S E R V I C E N O T E

3708A Noise and Interference Test Set**Serial Numbers:** 0000U00000/9999U99999**Mod to prevent blowing F2 and F3 fuses when switched on****Situation**

DATE: July 1999

Figure SN08A20
A501 Power Supply High Current Assembly

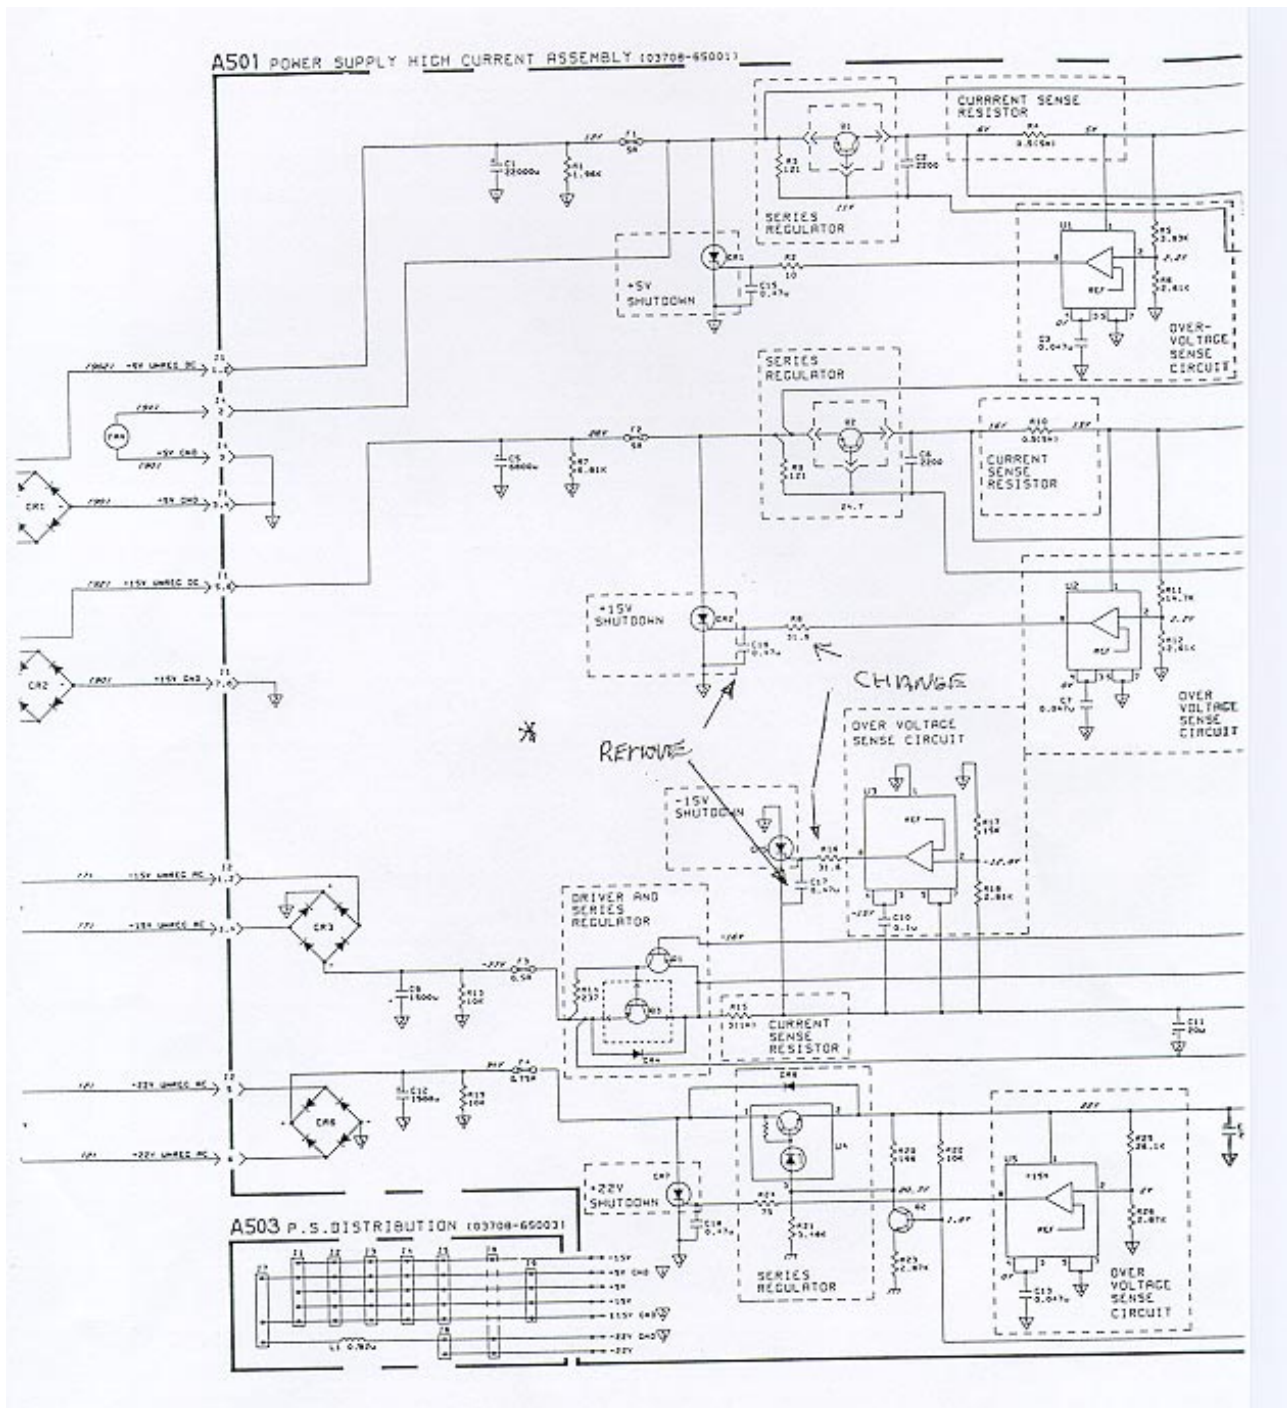
Recently there have been several 3708A's which have been randomly blowing fuses F2 and F3 on the 03708-65001 assembly when the instrument has been switched ON/OFF.

Remove R8 31.6ohms (0757-0180) and replace with 100ohms (0757-0401) Remove R16 31.6ohms (0757-0180) and replace with 100ohms (0757-0401)

The next part of the modification requires 2 capacitors to be removed - C16 and C17 (0160-4441).

Desolder the holes and fit 4 connector pins (1252-2499) in the empty holes of C16 and C17 and solder them in.

Connect C16 and R28 21.5ohms (0698-3430) in parallel across the pins in the C16 position.

Similarly connect C17 and R29 21.5ohms (0698-3430) in parallel across the pins in the C17 position.
